CITY OF ALBUQUERQUE

RE: **Lot 5 Block 4 Unit 19 SAD 228**
6540 Azor Rd. NW
Grading and Drainage Plan
Engineers Stamp Date 12/16/2023 (D10D003T5)

Based upon the information provided in your submittal received 2/7/2024, this plan is approved for Grading Permit.

ENGINEER'S SEAL	6540 AZOR	DRAWN BY WCWJ
DAVID SOULE NEW MEXICO 14522 REGISTERED PROFESSIONAL ENGINEER	GRADING AND DRAINAGE PLAN	DATE 2-05-24
2/6/24	Rio Grande Engineering PO BOX 93924 ALBUQUERQUE, NM 87199 (505) 321-9099	20240005-LAYOUT-2-05-24
P.E. #14522 DAVID SOULE		SHEET # —
		JOB # 20240005

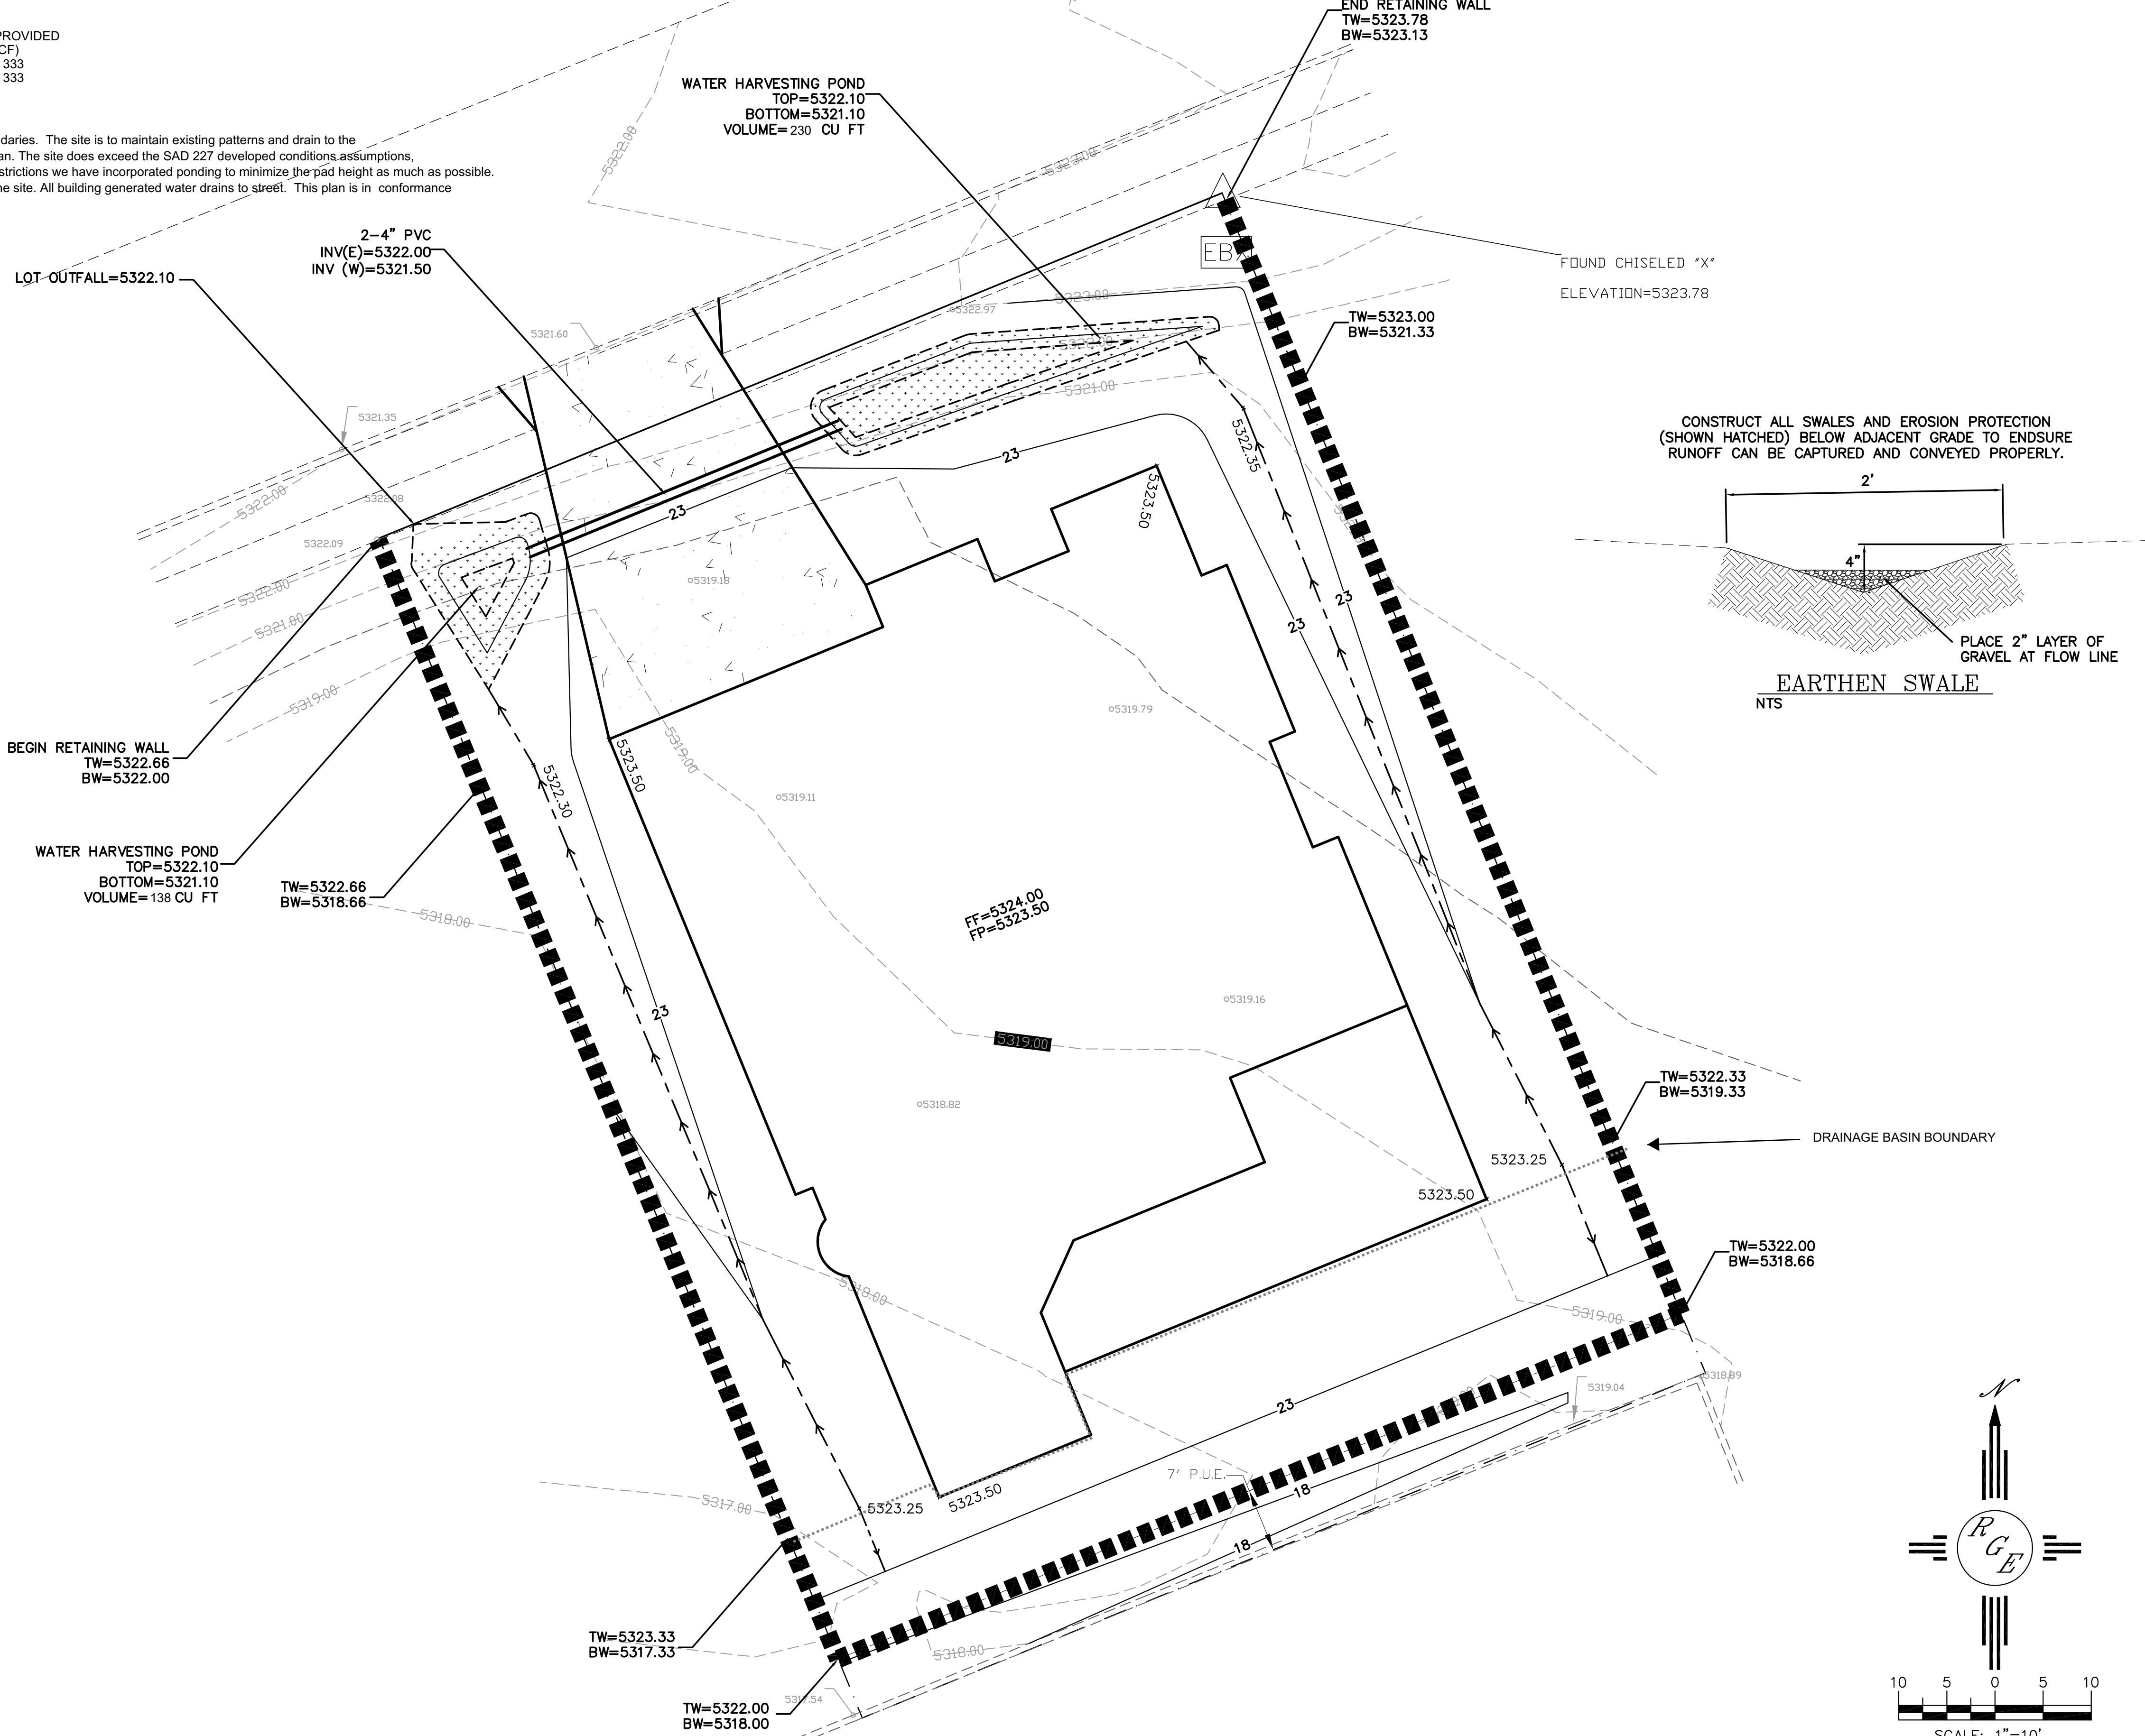
Prior to Building permit approval a Pad Certification will be required, provided by the Engineer or a registered Land Surveyor.

Advise the owner contractor not to use dirt as a ramp to climb the curb, use lumber or crusher fines for this purpose.

Reiterate to the Owner/Contractor that a separate permit for a garden/retaining wall must be obtained with the approved G&D plan and Pad Certification. Also, if a swimming pool is to be placed the grading and drainage plan will change and will need to be resubmitted.

Prior to Certificate of Occupancy release, Engineer Certification per the DPM checklist is required.
